# NOSECUP PARTS REVERSED

I noticed in the M40/M42 mask's TM 3-4240-346-23&P (Aug 10), the nosecup valve disk and the nosecup valve seat assembly are reversed in both Fig 2 and Fig 4 of WP 0031. The valve seat assembly is actually Item 2 in both figures and the valve disk is Item 3. I've submitted a DA Form 2028, but CBRN specialists might want to correct their TMs in the meantime.

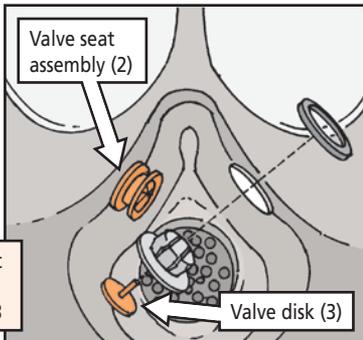
Nosecup valve seat assembly is Item 2.  
Valve disk is Item 3

*Editor's note: Good eye, Master Sergeant. CBRN specialists, make a note of this correction to save yourself parts confusion.*
